Closeout Report

*Department of Energy
Review Committee Report
on the*

LINAC COHERENT LIGHT SOURCE (LCLS) PROJECT

July 10-12, 2007

% Contingency Available (on remaining work)

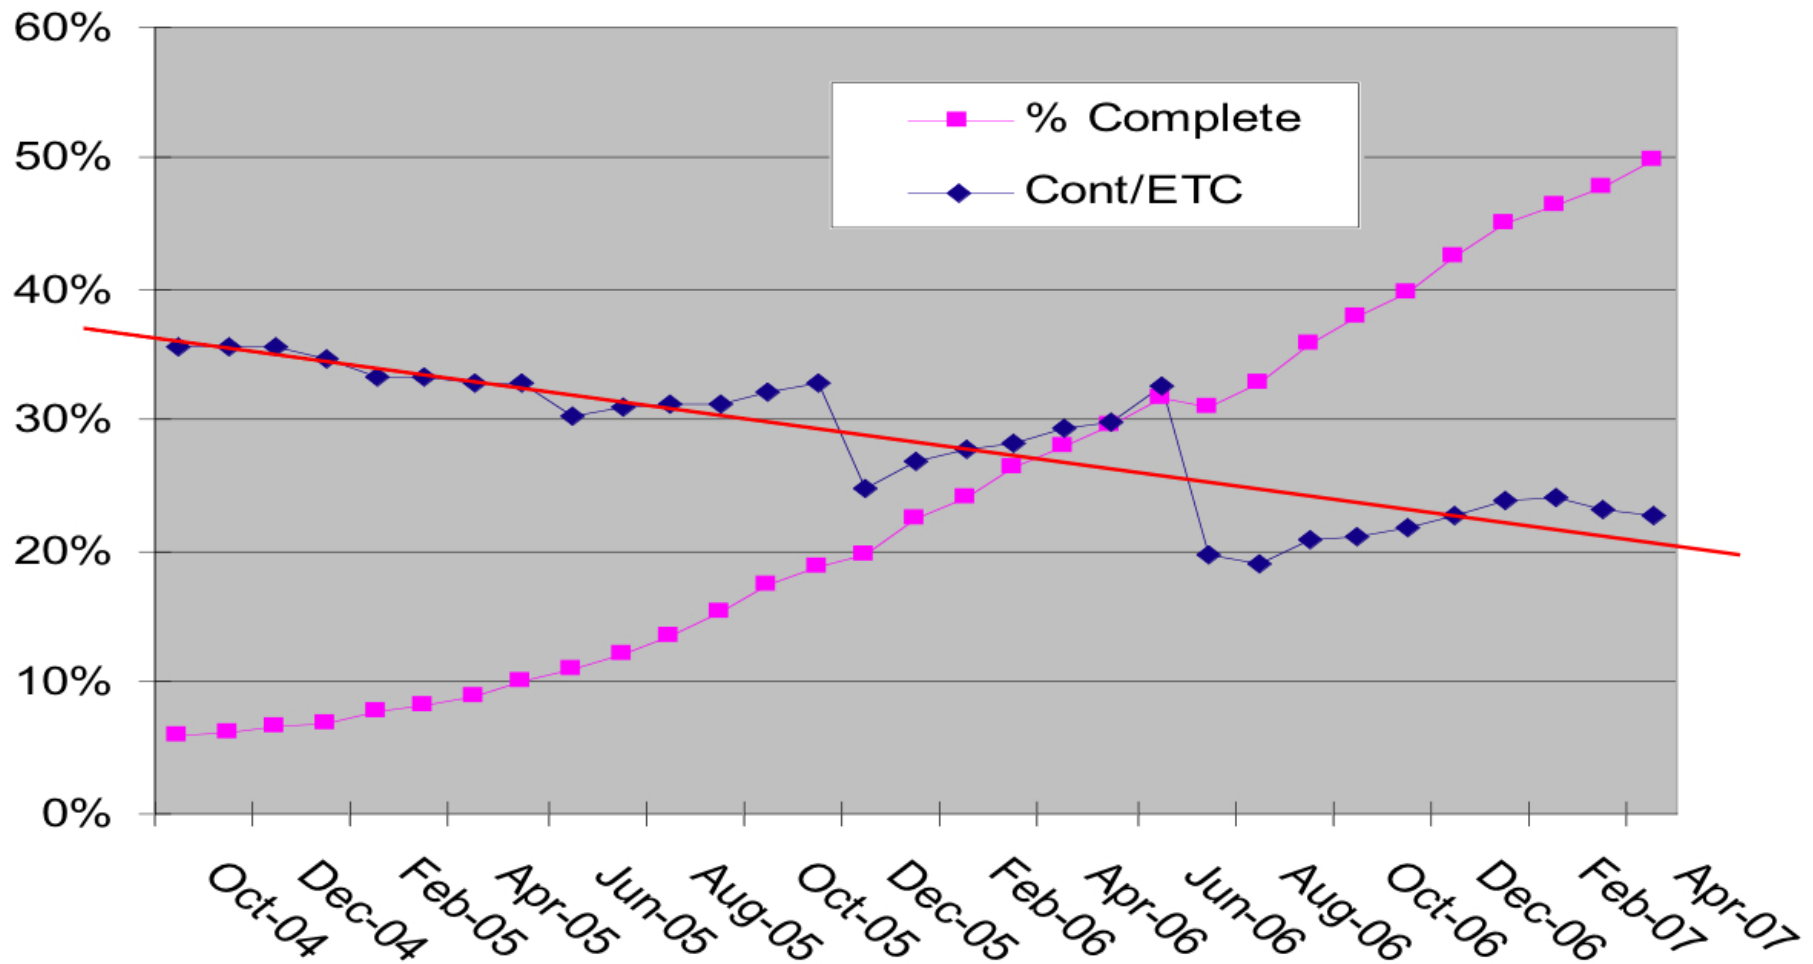
Metric of some concern
